STATE OF WASHINGTON  
DEPARTMENT OF ECOLOGY

April 9, 2020

**Re: Opinion Pursuant to WAC 173-340-515(5) on Remedial Action for the following  
Hazardous Waste Site:**

- **Name: Four Corners Cleaners New Location**
- **Address: 23886 SE Kent-Kangley Road, Maple Valley, WA 98038**
- **Facility/Site No.: 5867**
- **Cleanup Site ID No.: 12513**
- **VCP No.: NW3234**

**FIGURE 2**  
**SITE MAP**

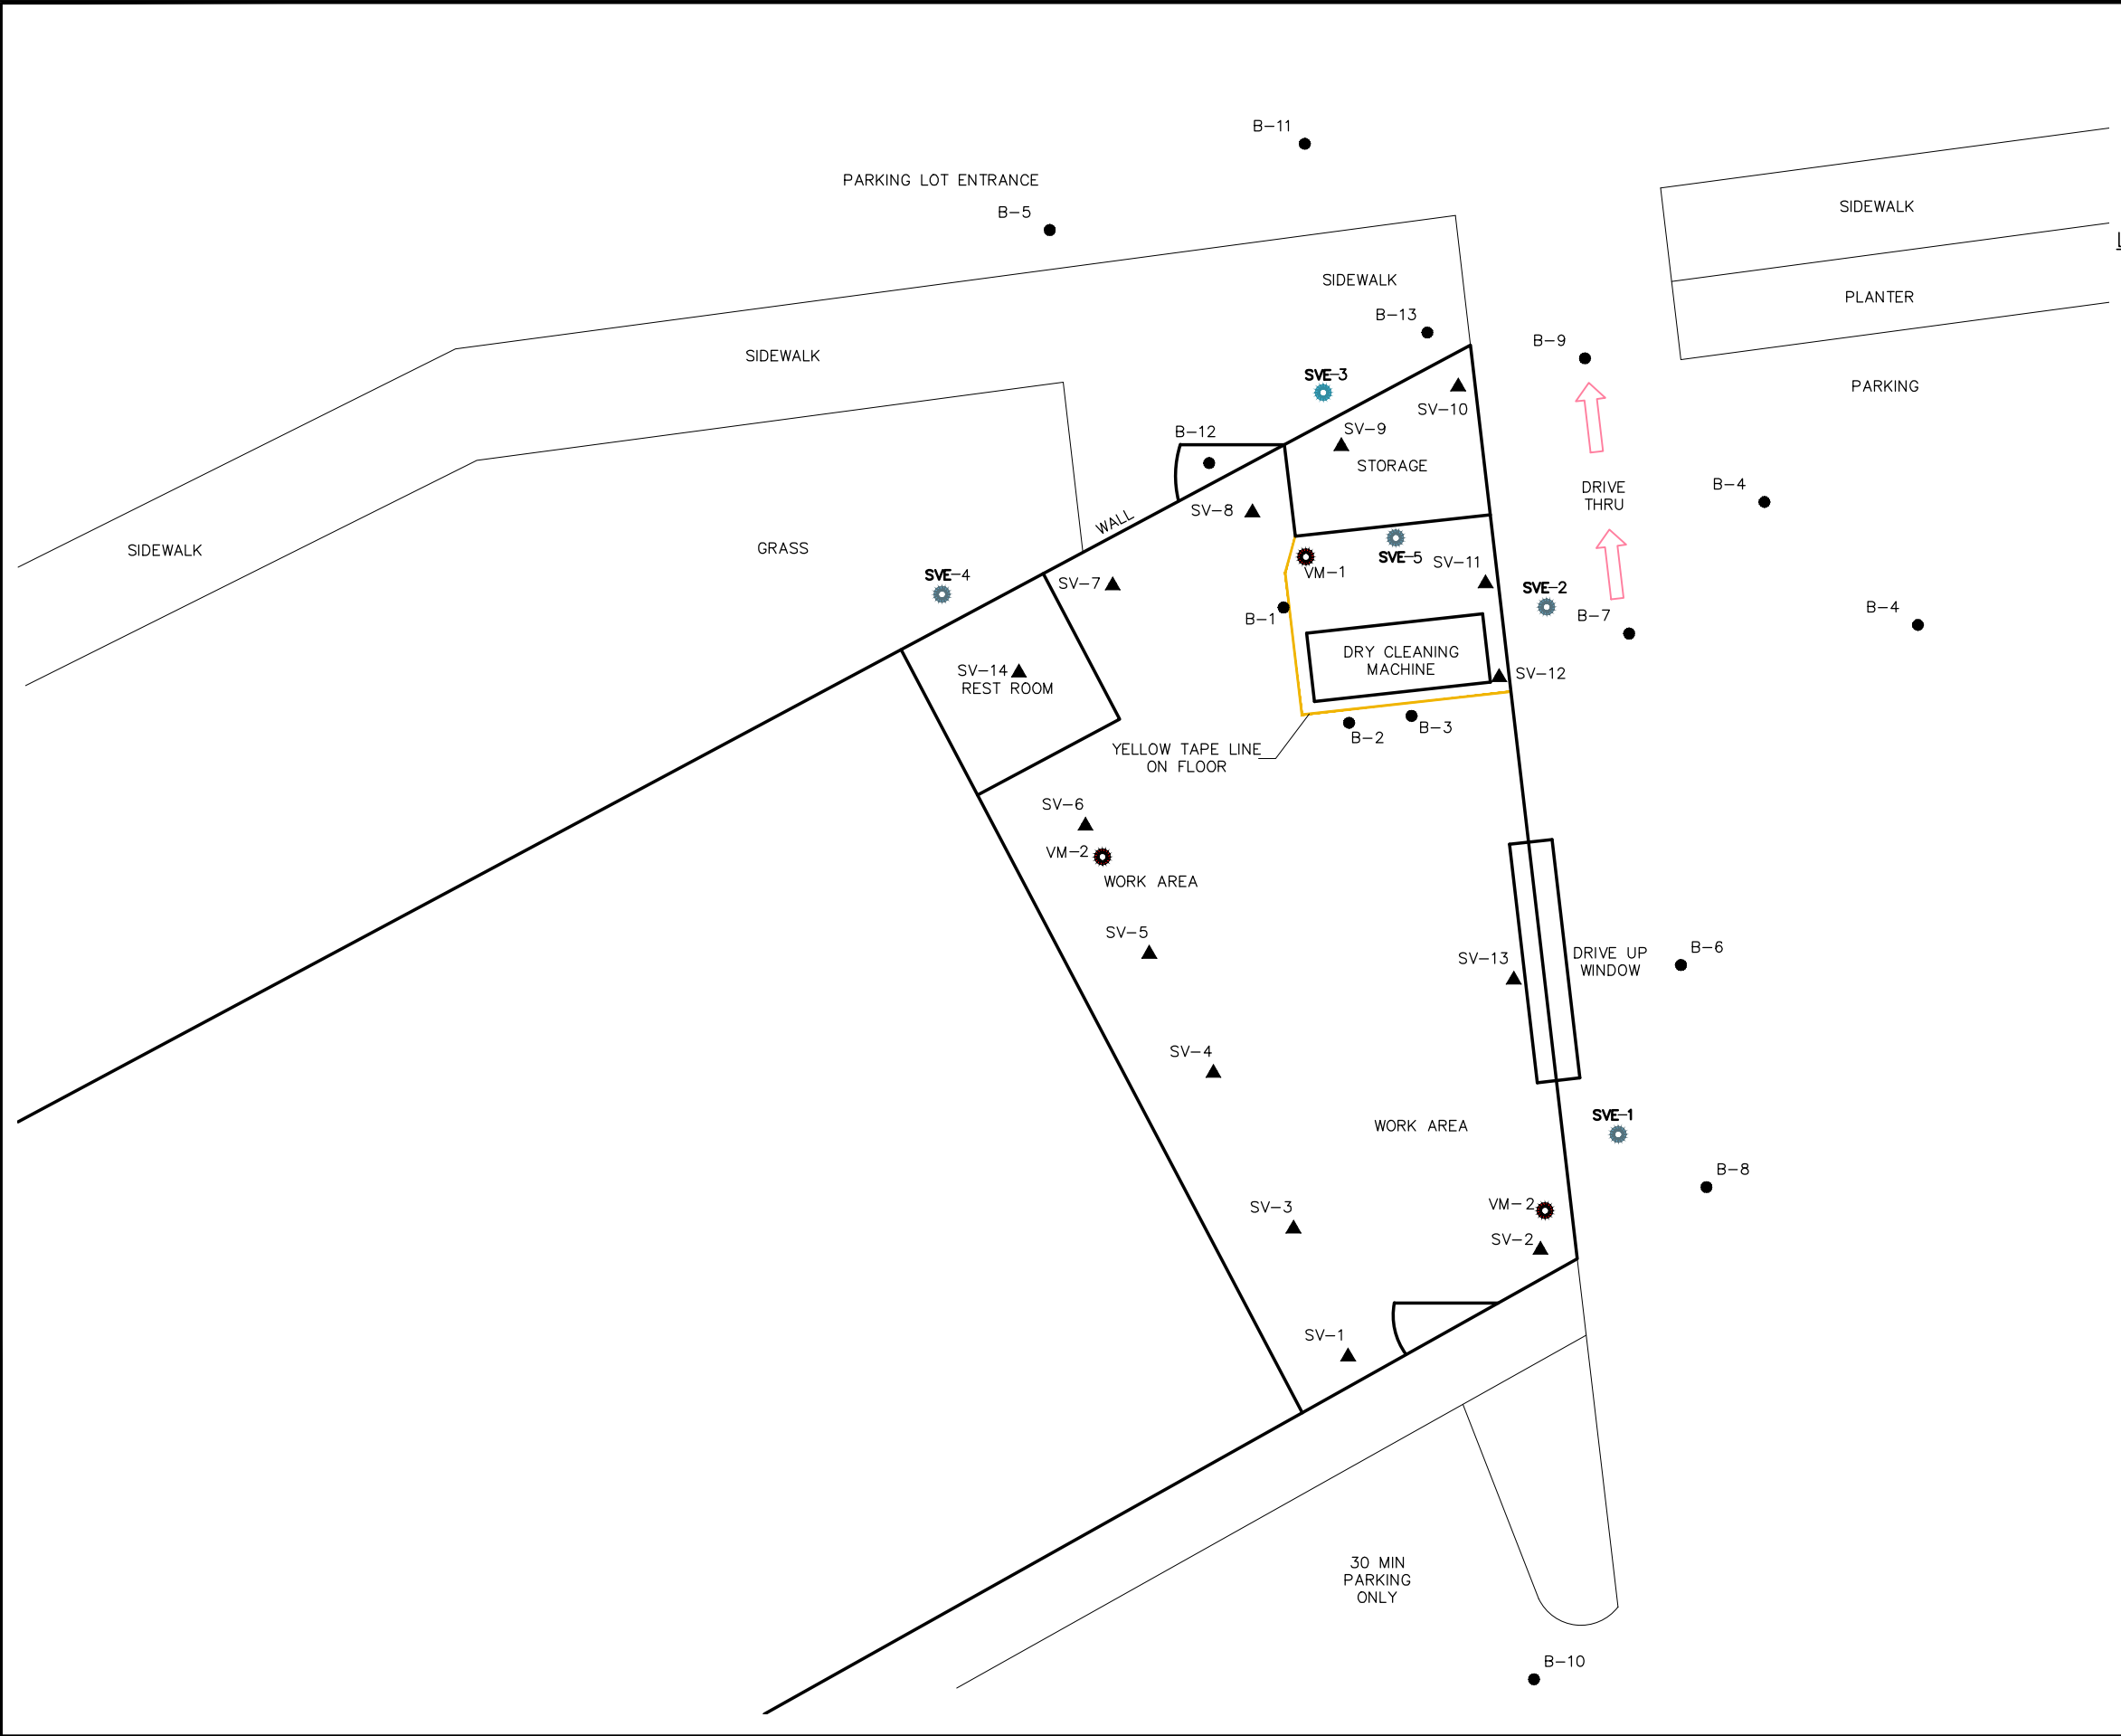
- Figure 2: Minor point; but unclear why the “VM” points are not labeled as “VP”?
- Process & Instrumentation Diagram (Figure 8): Minor point; but unclear: why does the intake manifold shown here have three lines instead of five lines?
